9 October 2015

### Exhaust Fan Switching Model No.: FV-24 series

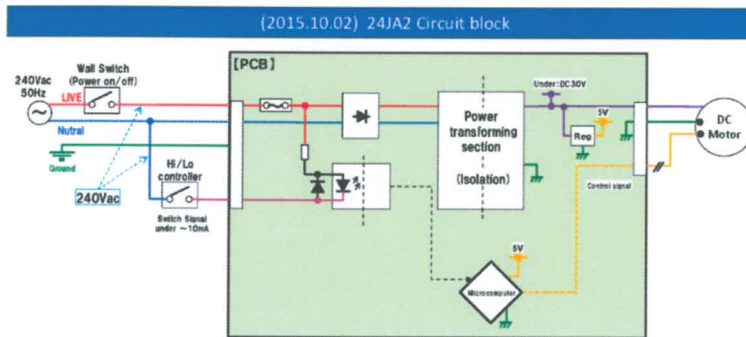
- The "Hi/Lo" switch is a "functional switch" (reference AS/NZS 3000 Wiring Rules Clause 2.3.7. It is required for operational control only and not for safety reasons (Cl. 2.3.7.1).
- Functional switching devices need not switch all active conductors of a circuit (Cl. 2.3.7.2).

- Wall switch is on / off switch of 240Vac.
- Hi / Lo controller is a switch for signal processing.
- DC motor is connected to the isolation power supply.
